LIGHTING PROPOSAL DOCUMENT

P2 BUILDING, EXTERIOR KINGS CROSS, LONDON

Document Reference: KXC-P2-001-J-00944-63-904

Stage 4.

South Elevation - Facade Lighting

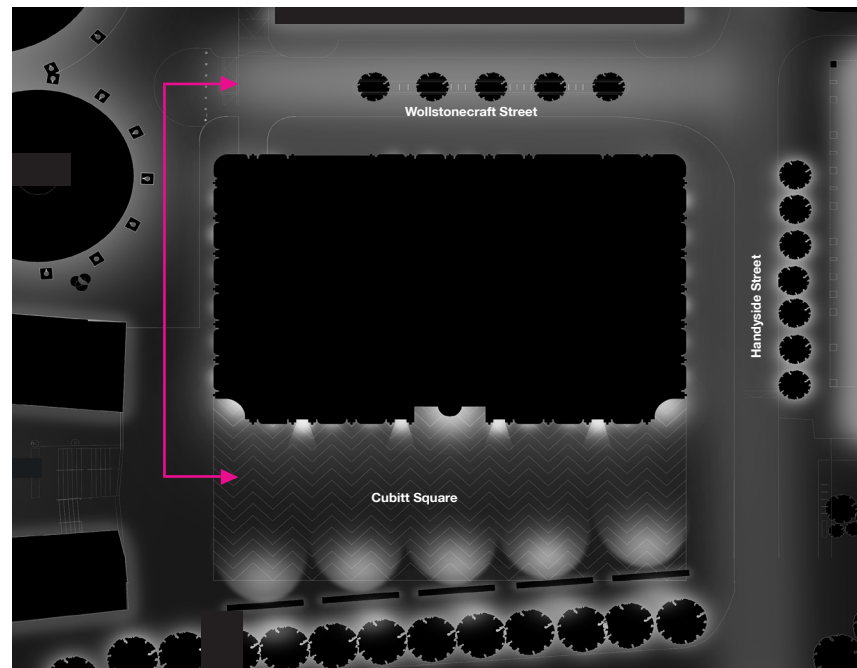
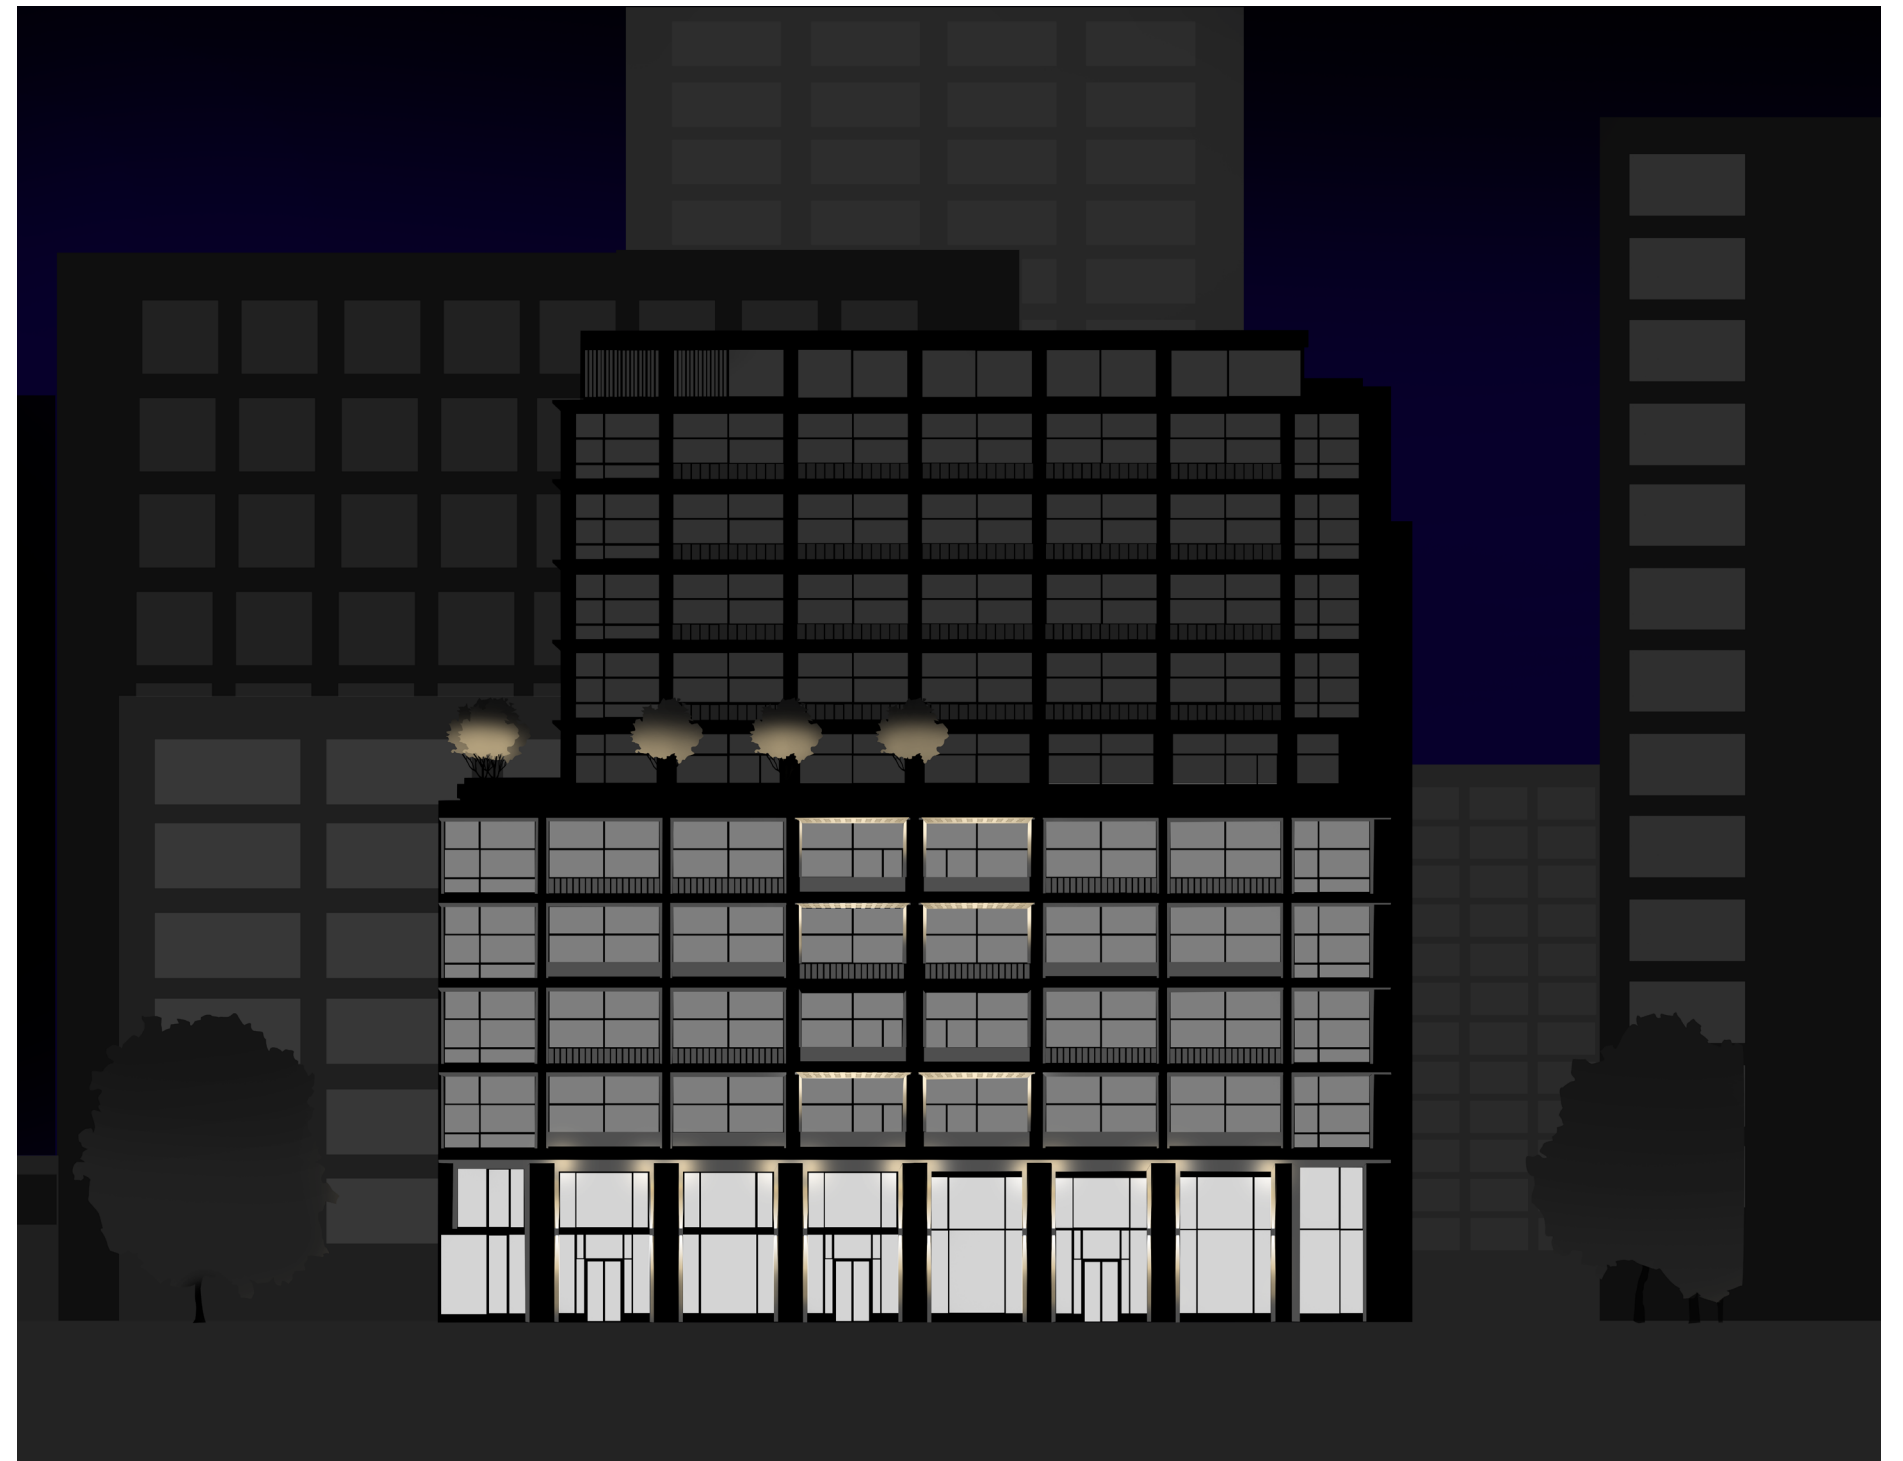
1. Respecification of Reference YD luminaires within fifth floor plants, for improved efficacies and BREEAM compliance.

East Elevation - Facade Lighting

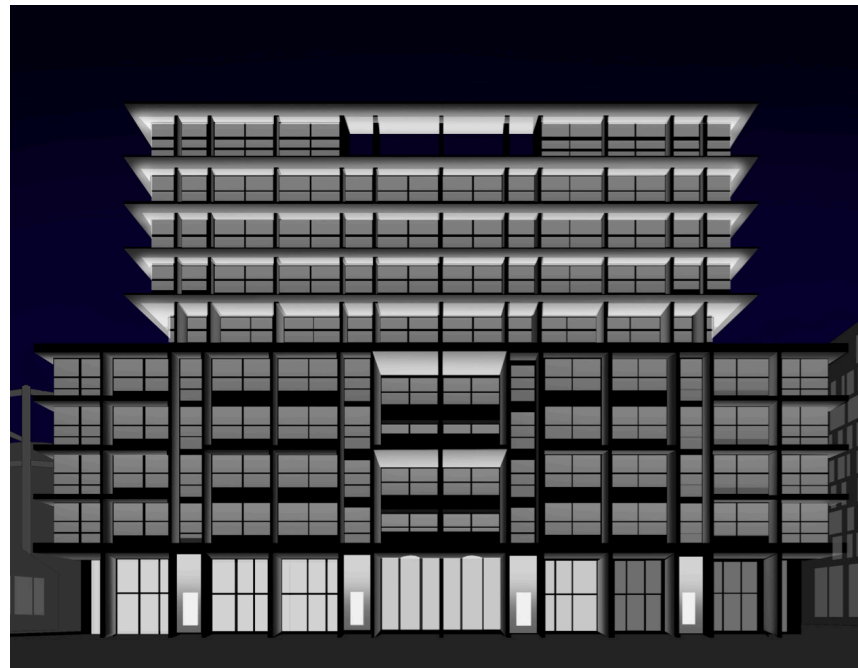
1. Amended Loggia lighting, to include respecified XB linear LED luminaires.
2. Omission of some Reference XG luminaires from Loggia Soffits.
3. Respecification of 'Crown' Lighting to Reference XJ, direct / indirect Luminaires.
4. Respecification of Reference XK linear luminaires to provide wash of illumination to soffit above entrance.

West Elevation - Facade Lighting

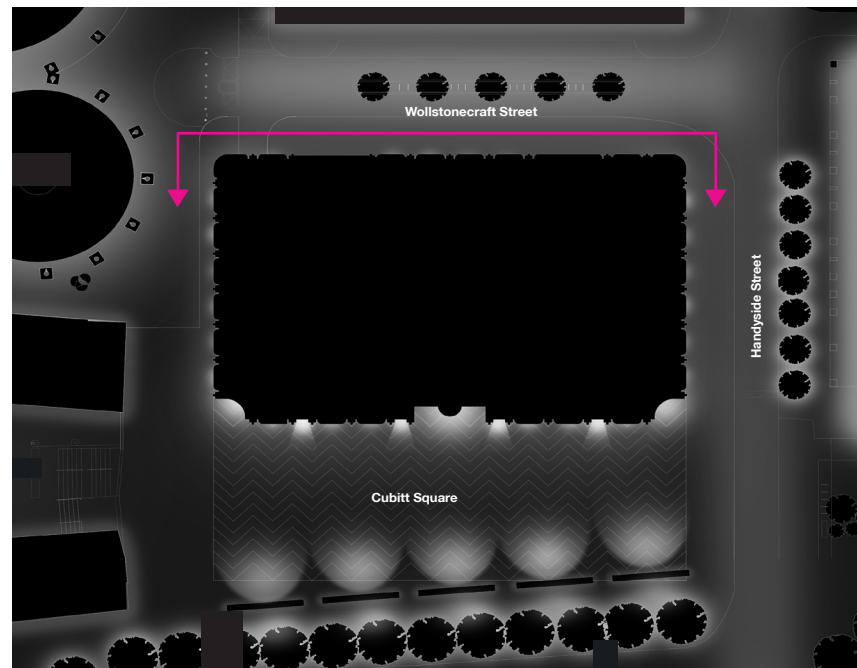
1. Amended Reference XJ arrangement.
2. Omitted feature flood lighting within loading bay.
3. Respecification of Reference XK linear luminaires to provide wash of illumination to feature shutter.
